PCB is designed for the 3d printed split flap display:
<https://www.printables.com/model/69464-split-flap-display>
 Each PCB can power four modules. Modules can be chained together to build larger displays

The Raspberry Pi Pico and OKL785R DC-DC regulator are optional, and should only be installed on the first module in the chain

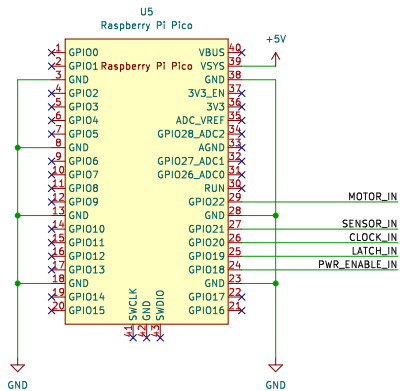
CHECK: Are all these caps correct?

CHECK: Are all these caps needed near VCC on each IC?

LEDs to indicate +5v and +12v power
 CHECK: Resistor values

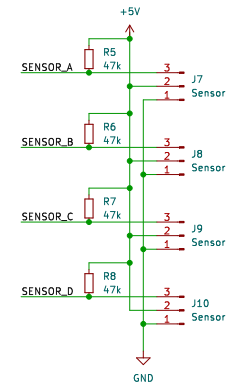
CHECK: Value for the pull up resistors R3 & R4
 Is only one pullup resistor needed on PWR_ENABLE_IN?

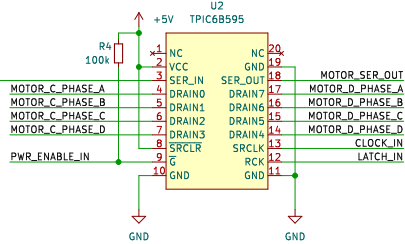
CHECK: I have seen other designs use 74HC595 and ULN2803 (or equivalent). Is it ok to replace them with TPIC6B595?

CHECK: Should SENSOR_OUT also be buffered?
 CHECK: Does MOTOR_OUT need to be buffered with TPIC6B595?
